Economic Commission for Europe**Inland Transport Committee****World Forum for Harmonization of Vehicle Regulations****Working Party on Passive Safety****Sixty-second session**

Item 17 of the provisional agenda

UN Regulation No. 129 (Lateral collision)**Proposal for the 03 series of amendments (Phase 3) to UN Regulation No. 129 (Enhanced Child Restraint Systems)****Submitted by the expert from France***

Figure 2

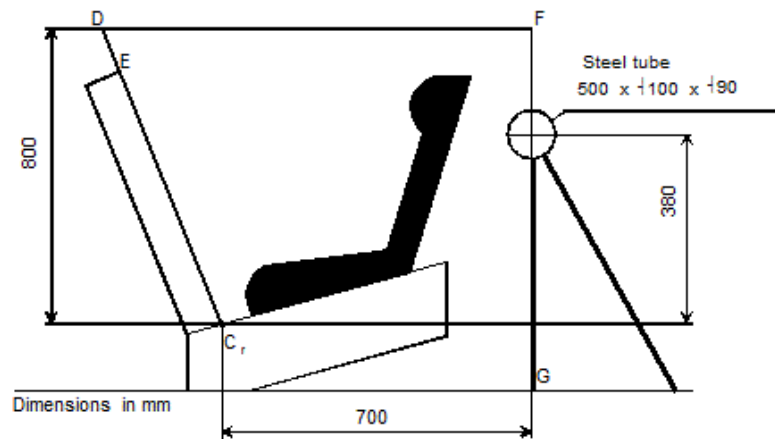
"6.6.4.4.1.2.1. Head excursion: no part of the head of the dummy shall pass beyond the planes FD, FG and DE, as shown in figure 2 below. This shall be judged up to 300 ms or the moment that the dummy has come to a definitive standstill whatever occurs first.

Except when testing using Q6 or Q3 dummy where the value in relation to the FD plane is 840 mm

Where a test is conducted with paragraphs 6.6.4.1.6.[21.1. or paragraph 6.6.4.1.6.1.2.] or paragraph 6.6.4.1.8.2. above, only the second configuration test results without 100 mm diameter bar will be considered.

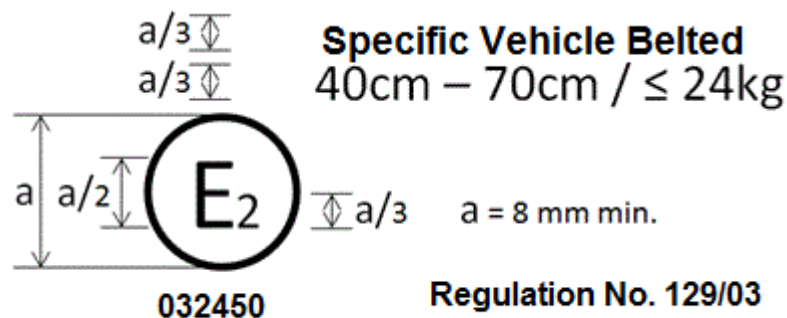
In the figure replace i-Size universal ISOFIX by Universal Belted, delete the mass limit and replace 02 by 03

Figure 1
Procedure type 1

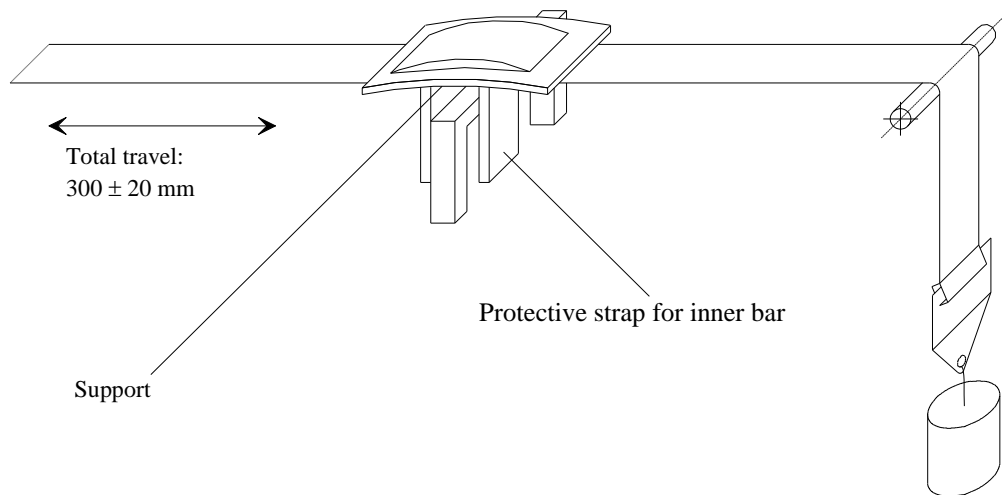
$F = 10 \pm 0.1 \text{ N}$, can be increased up to maximum $F = 60 \pm 0.5 \text{ N}$ (see table 8, paragraph 7.2.5.2.6.2.)

Type 1 procedure: for cases where the strap slides through the quick adjusting device. Apply a load of 10 N, if necessary the load may be increased by 10 N steps so as to permit correct sliding, but limited to a maximum of 60 N. This load shall be vertically and permanently applied on the straps. The part of the strap set horizontally shall pass through the quick adjuster it is fitted to and shall be attached to a device, giving the webbing a back and forth motion. The quick adjusting device shall be so placed that the horizontal strap of the webbing remains under tension (see Annex 5, Figure 1). Activate the quick adjuster while pulling the straps in the direction to slacken the harness and deactivate it while pulling the straps in the direction to tighten the harness.

Figure 2
Procedure type 2
 Following two examples of test set up

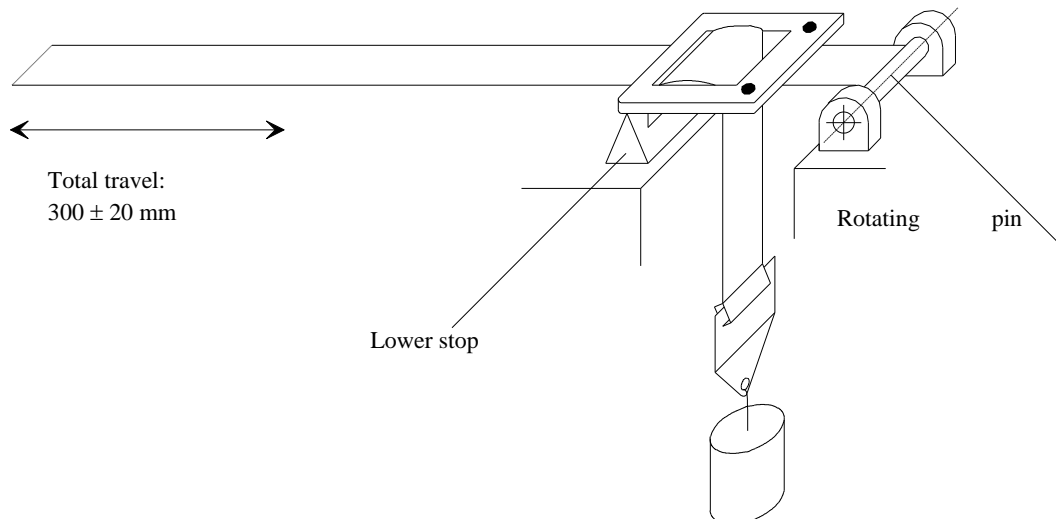
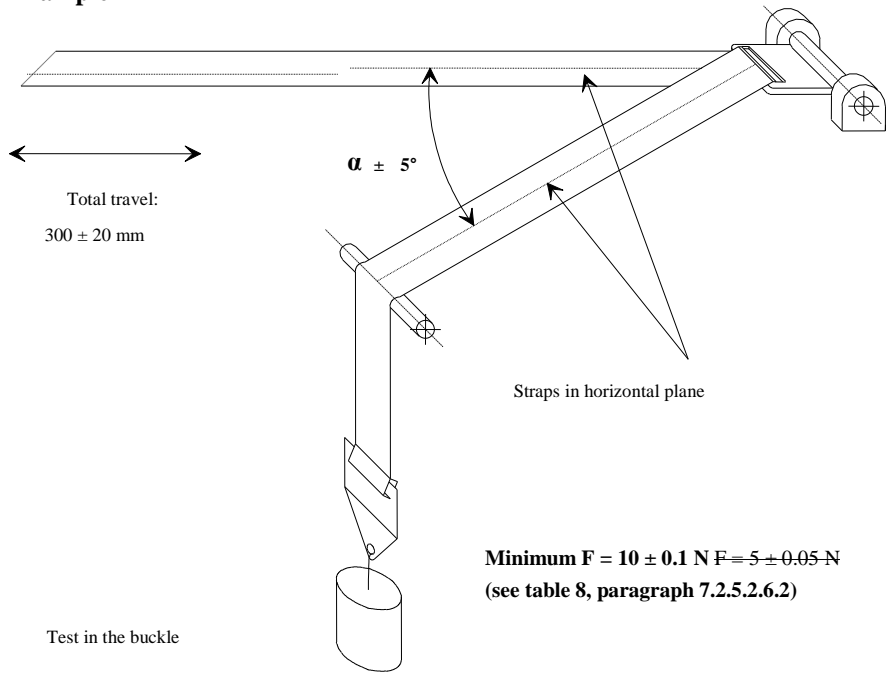
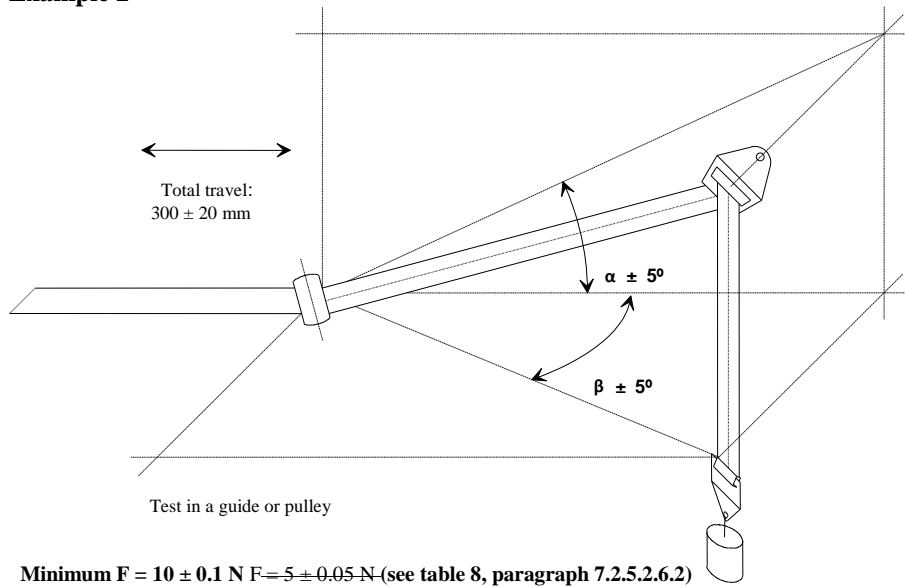
Where α and β reproduce the angles as in the real installation (in three dimensions)
 ..."

Type 2 procedure: for cases where the strap changes direction when passing through a rigid part. During this test, the webbing shall pass through the rigid part it is intended for and the test set-up shall reproduce the angles as in the real installation (in three dimensions), see Annex 5, Figure 2 for examples. The 10 N load shall be permanently applied. For cases where the strap changes direction more than once when passing through a rigid part, the load of 10 N may be increased by

"Figure 5
Lower strap anchorages (LSA 1, LSA 2, LSA 3 and LSA 4)

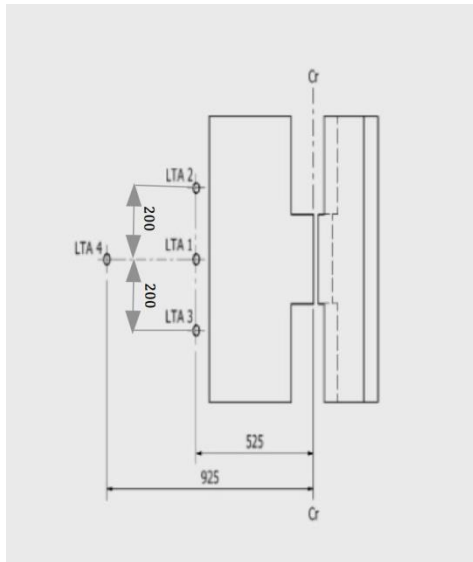
Annex 6, Appendix 2, insert new figure 5:
